19 May 2021

**Loreto Normanhurst Concept Plan and Stage 1 Works – SSDA 8996  
Response to Submission**

**Figure 2 Proposed bicycle parking facilities**

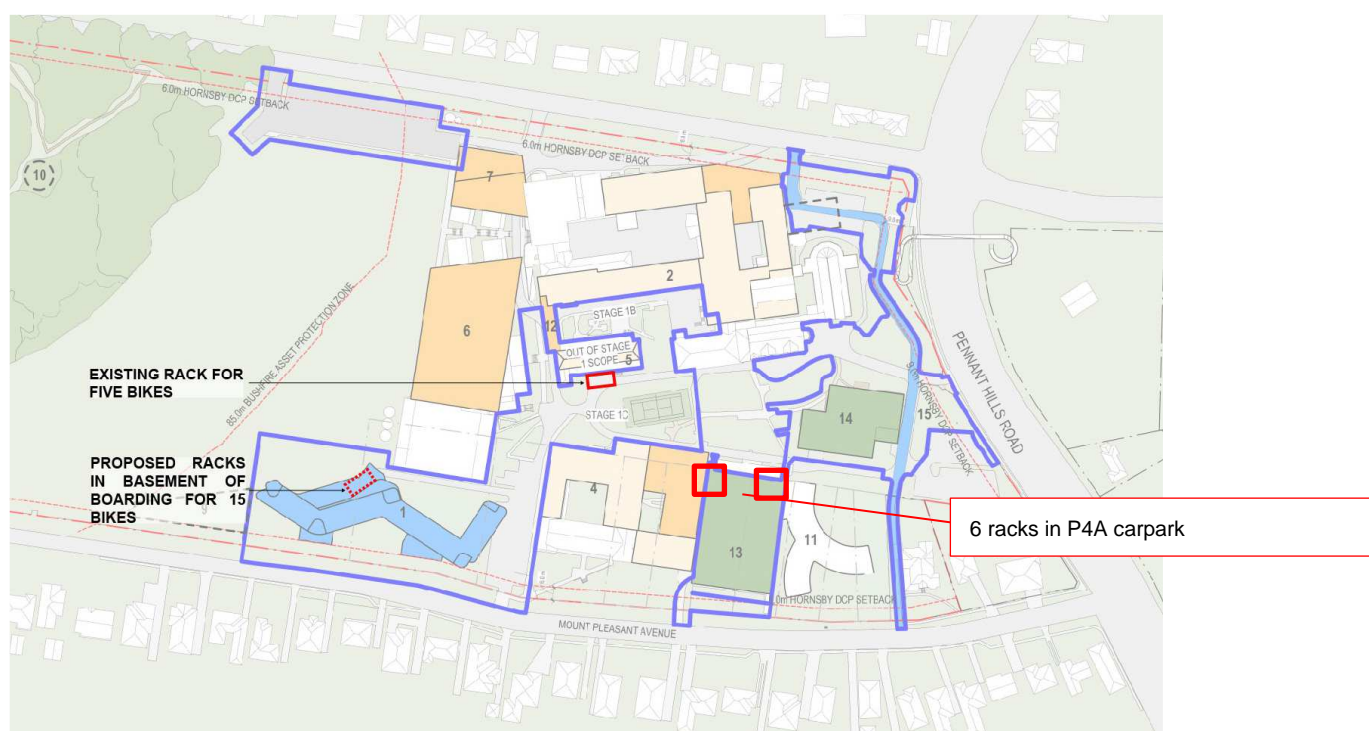
It is noted that Council's requirement is per rack of bike parking and does not specify the number of spaces within a rack.

Bicycle parking requirements for the Concept and Stage 1 DA are outlined at **Table 1** below and discussed in further detail at **Appendix A**. Accordingly, the project will satisfy bicycle parking requirements.

**Figure 4 Proposed Queuing locations**

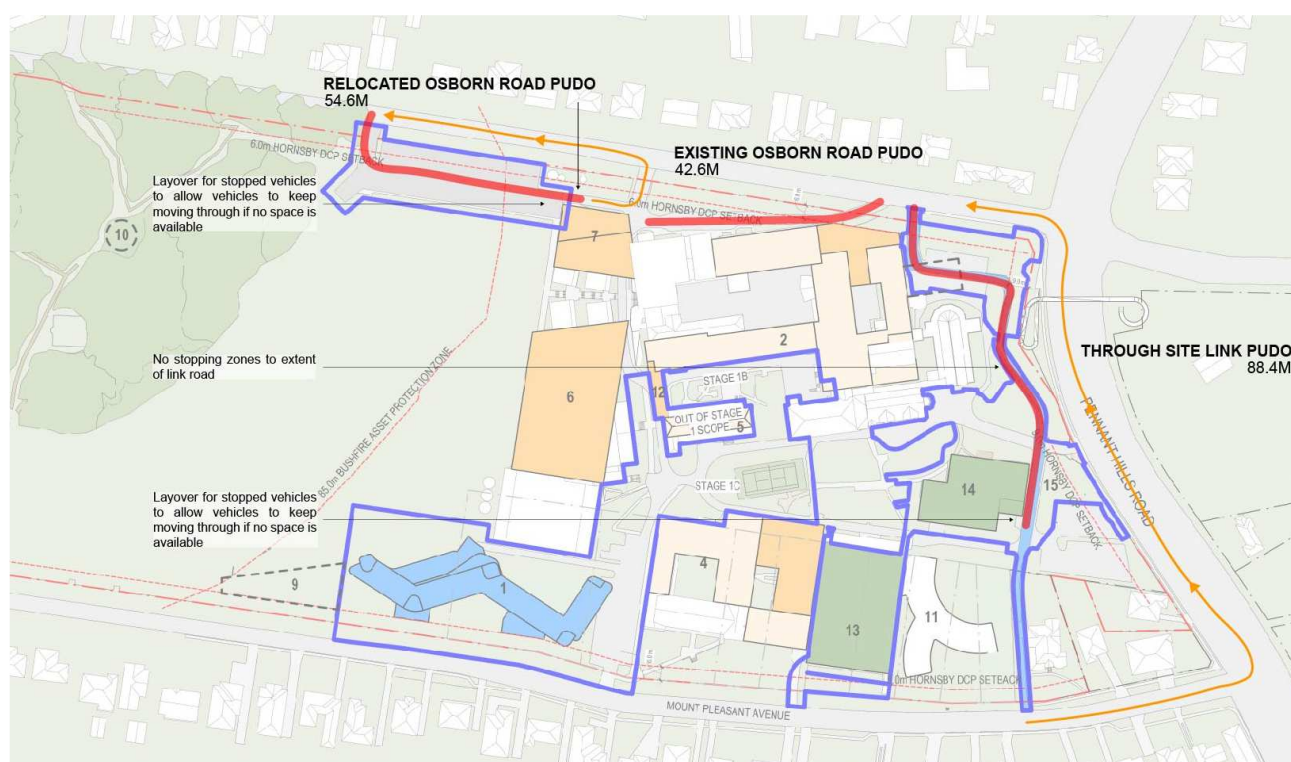
Queuing length resulting from pickup/drop off facilities should be included in the volumes of Figure 6.1 sic [of the Traffic Report]. Determine if there will be any extensive queues line up during sharp peak times (8am-8:20am and 3:15pm-3:30pm). Results should also relate to spill back into Osborn Road The statement "It was observed on site that some queuing can occur during peak periods as a result of the above geometrical constraints and driver behaviour." in s 6.1.2 needs to be quantified

The volumes in Figure 6.1 of the original Traffic Report dated 15 January 2020 included in the first response to submissions provide movements into and out of the existing pick up and drop off facility and has been used to project the future demands of the pick-up and drop-off facility. The proposed pick up and drop off facility will provide through lanes to enable recirculation and will be marshaled to prevent queuing onto adjacent streets.

As stated in the current Traffic RtS Report (**Appendix A**), the existing pick up and drop off facility is insufficient in terms of length for drop off and has existing geometry that discourages recirculation by drivers. For this reason the relocation of this drop off is proposed as part of the Stage 1 works. Refer to **Figure 4** for proposed queuing locations. As part of the ELC approval process, drone surveys were undertaken in September 2019 of the intersections of Osborn Road and Mount Pleasant Avenue with Pennant Hills Road to review queue lengths within Osborn Road. These surveys identified a 9 vehicle queue, refer to Appendix B in the Traffic Report for a copy of this report.

**Figure 5 ELC Car Parking diagram**

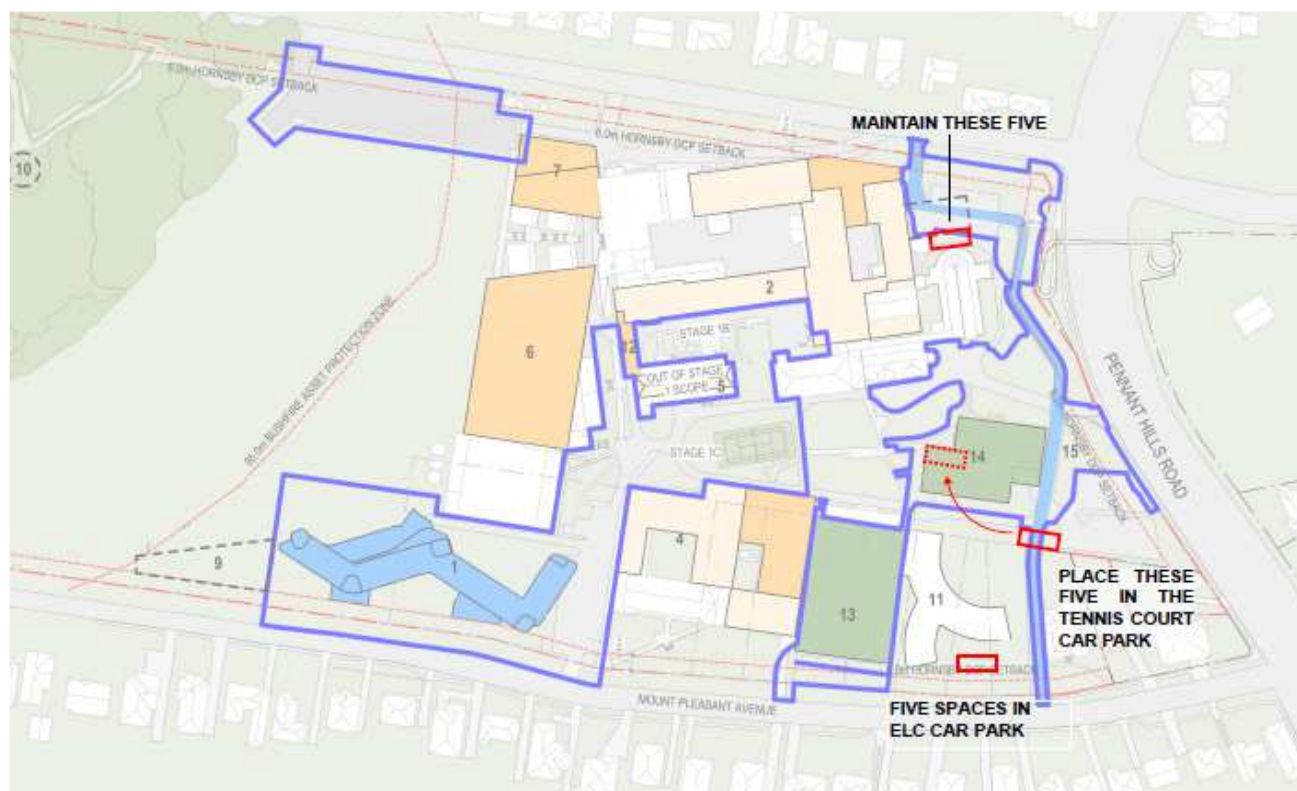
Please confirm the location of the 15 car parking spaces to be dedicated for Early Learning Centre use.

The 15 spaces required for the Early Learning Centre development application will be located within the spaces shown in Figure 1 in the Transport Response to Submission (RtS) Report, once the P1A carpark and through site link is constructed, the parking spaces that will be impacted by the works (at location 'B' and 'D' in figure 1 of the Traffic RtS Report) will be located within the P1A car park. These spaces will be clearly line marked as well as indicated to staff as part of the staff allocation discussed in Section 6.2.1 of the Operational Traffic Management Plan. See **Figure 5** below and **Appendix A** for further details.
